APPLICATION NO.	FILING DATE	FIRST NAMED INVENTOR	ATTORNEY DOCKET NO.	CONFIRMATION NO.
10/524,018	02/09/2005	Murray Douglas Jones	4505-1037	7567
466	7590	06/22/2007		
YOUNG & THOMPSON 745 SOUTH 23RD STREET 2ND FLOOR ARLINGTON, VA 22202			EXAMINER VALENTI, ANDREA M	
			ART UNIT 3643	PAPER NUMBER
			MAIL DATE 06/22/2007	DELIVERY MODE PAPER

Office Action Summary	Application No. 10/524,018	Applicant(s) JONES ET AL.	
	Examiner Andrea M. Valenti	Art Unit 3643

DETAILED ACTION

Fig. 1.

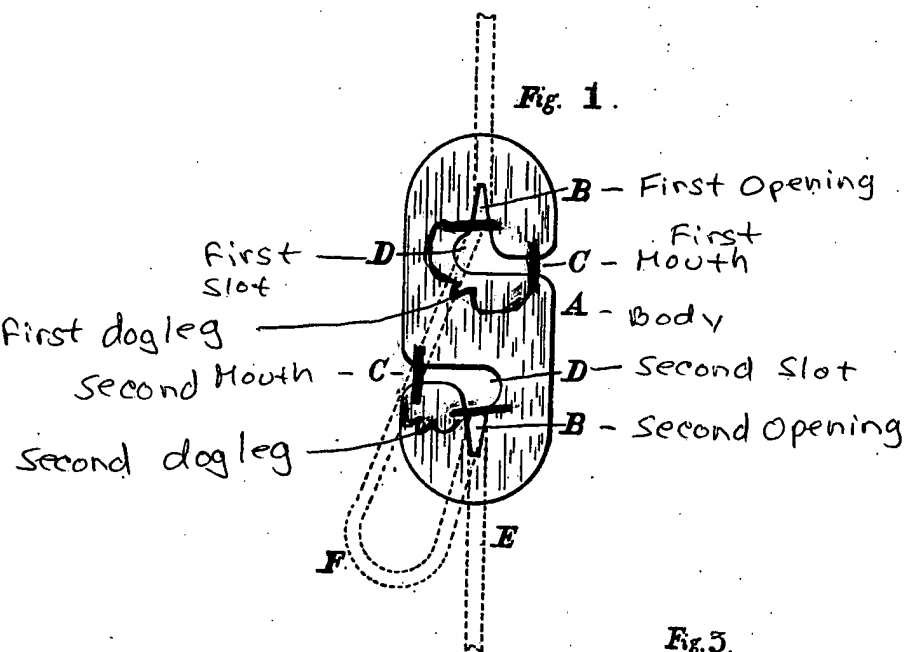
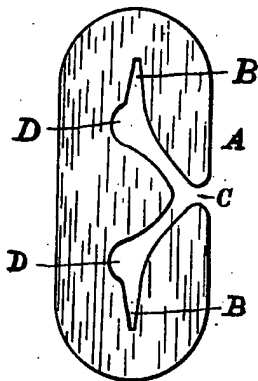
Regarding Claim 32, Heaphy teaches a clip including a body (Heaphy Fig. 1, see attached Fig. 1 for identification of claimed features), a first opening within the body and

Regarding Claims 18 and 19, Heaphy as modified teaches the first slot is of doglegged form (See attached Heaphy Fig. 1).

Regarding Claims 20 and 21, Heaphy as modified teaches the first and second slot has a widened mouth at the edge of the body (Heaphy Fig. 1 element C).

Regarding Claim 25, Heaphy as modified teaches the wall has rounded edges (Heaphy Fig. 1 and Tupper Fig. 1).

Regarding Claim 26, Heaphy as modified teaches the clip is symmetrical about central longitudinal and lateral axes (Heaphy Fig. 1).

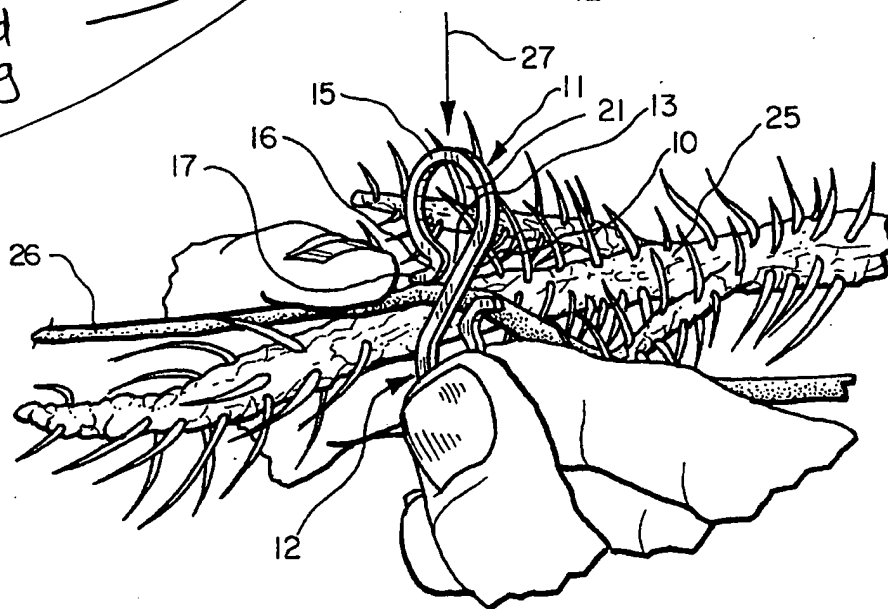
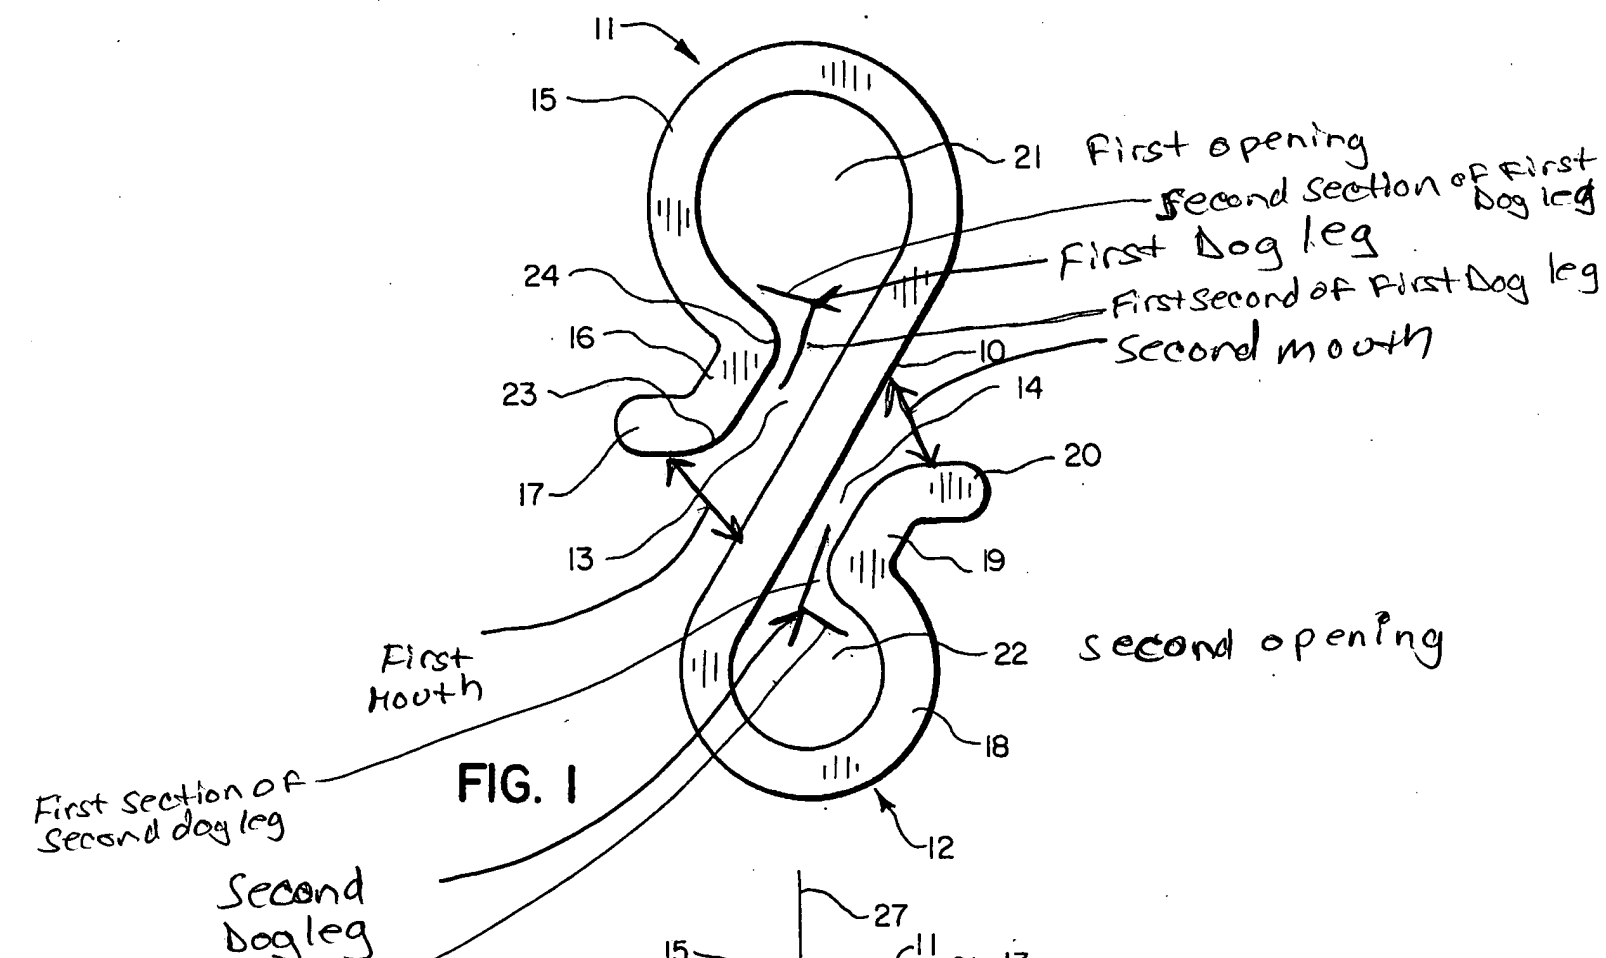
Regarding Claim 32, Swenson teaches a clip including a body (Swenson Fig. 1), a first opening (Swenson Fig. 1 #21) within the body and in which, in use, a part of a plant can engage (Functional language, Swenson Fig. 2); a first slot (Swenson Fig. 1 #13) extending between the first opening and a first edge of the body, a second opening (Swenson Fig. 1 #22) within the body, a second slot (Swenson Fig. 1 #14) extending between the second opening and a second edge of the body, wherein the second slot extends from the second edge of the body, which is opposite the first edge from which the first slot extends.

Regarding Claims 18 and 19, Swenson as modified teaches the first slot is of doglegged form (Swenson fig. 1 #13/#17 and #14/#20).

Regarding Claims 20 and 21, Swenson as modified teaches the first and second slot has a widened mouth at the edge of the body (Swenson Fig. 1 between #17 and 10 and between #20 and 10).

Regarding Claim 29, Swenson teaches a clip including a body (Swenson Fig. 1 #11), a first opening (Swenson Fig. 1 #21) within the body and a first slot (Swenson Fig. 1 #16 and 13) extending between said first opening and an edge of the body, a second opening (Swenson Fig. 1 #22) within the body and a second slot (Swenson Fig. 1 #14) extending between the second opening and an edge of the body which is opposite to that from which the slot extends, said first and second slots each being of doglegged (Swenson Fig. 1 see attached) form and which extends from a widened mouth at the edge (Swenson Fig. 1 between #17 and 10 and between #20 and 10) of the body said clip being symmetrical about a central longitudinal axis, wherein, each mouth is

separate from said doglegged form; each of said first opening and said second opening is wider in cross-section than a cross-sectional width of the corresponding first slot and the corresponding second slot (Swenson Fig. 1 #21, 22, 13, 14).

Regarding Claims 37 and 34, Swenson teaches the first and second doglegged slots each has a first portion which extends at an angle to the edge of the body, the first slot further has a second portion which inclines away from the first portion and extends to the first opening within the body and the second slot further has a second portion which inclines away from the first portion and extends to the second opening within the body (See attached Swenson Fig. 1).
